Access Compliance Report Public Rights-of-Way (Curb Ramps)

Intersection ID: 7913 Main Street: BROOKSHIRE_BV Cross Street: N_CLOUDMAN_ST Location: N

ADA ID: 53AC135051FE Ramp Type: Para Initial Pass/Fail: Fail Overall Compliance: No Severity Score: 13.75

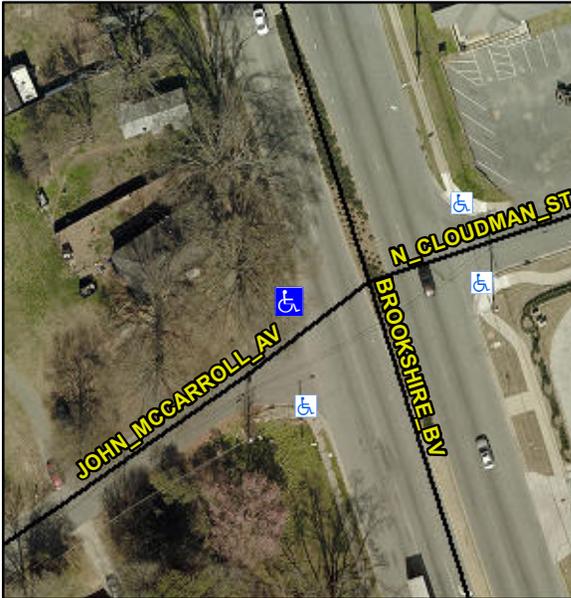
LT RP < 5%

R304.3.2, R304.5.3

Compliance	Description	Data	Compliance	Description	Data
N/A	Ramp Length LT (in)	54.0	N/A	Ramp Length RT (in)	45.0
Yes	Ramp Width LT (in)	84.0	Yes	Ramp Width RT (in)	84.0
Yes	Ramp Slope LT (%)	1.5	No	Ramp Slope RT (%)	10.5
Yes	Ramp XSlope LT (%)	0.2	No	Ramp XSlope RT (%)	3.3
N/A	Landing Length (in)	N/A	N/A	DWS Provided?	N/A
N/A	Landing Width (in)	N/A	N/A	DWS Contrast?	N/A
N/A	Landing Slope (%)	N/A	N/A	DWS Length (in)	N/A
N/A	Landing X Slope (%)	N/A	N/A	DWS Full Width?	N/A
N/A	Landing Curb? (Y/N)	N/A	N/A	DWS Offset (in)	N/A
N/A	Shared Landing?	N/A			
N/A	Gutter Ponding?	N/A	N/A	Gutter Slope (%)	N/A
N/A	Gutter Lip Ht (in)	N/A	N/A	Gutter X Slope (%)	N/A
N/A	Painted X Walk1?	No	N/A	Painted X Walk2?	N/A
	X Walk 1 Direction	To S		X Walk 2 Direction	N/A
N/A	X Walk 1 Width (in)	N/A	N/A	X Walk 2 Width (in)	N/A
	X Walk 1 Slope (%)	1.8		X Walk 2 Slope (%)	N/A
	X Walk 1 X Slope (%)	2.4		X Walk 2 X Slope (%)	N/A
N/A	Ramp inside XWalk1?	N/A	N/A	Ramp inside XWalk2?	N/A

Remove & Replace Entire Ramp.
